Project No: 151-01887-00

**RE: R.M. OF TACHÉ – COMMUNITY OF LORETTE
WASTEWATER TREATMENT LAGOON EXPANSION -
NOTICE OF ALTERATION – FILE No: 4482.10**

TITLE:
R.M. OF TACHE -
COMMUNITY OF LORETTE -
NOTICE OF ALTERATION -
PROPOSED PIPE INSTALLATION

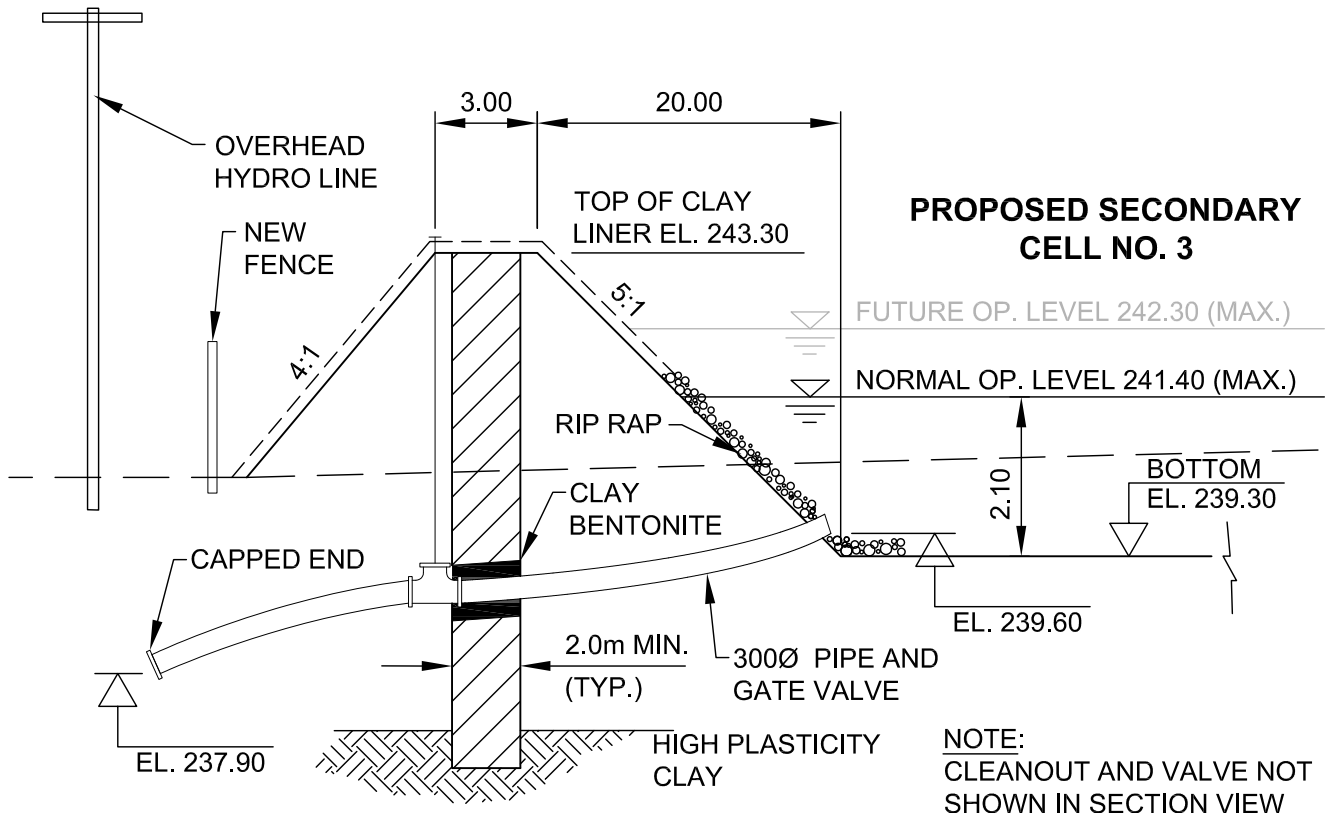
We propose that a 300 mm diameter (HDPE) pipe segment complete with gate valves and cleanout be installed through the south dyke of the proposed secondary cell 3 (see attachment). The pipe would be capped off on the outside of the dyke and would not be used at this time.

that would be made. The submission would also include a lagoon capacity review. The intent is to install the pipe, valves and cleanout during the construction associated with the Lorette lagoon expansion, scheduled for 2016. Completing the installation at this time would allow the R.M. to complete a future connection between the lagoons without disturbing the dyke of secondary cell 3.
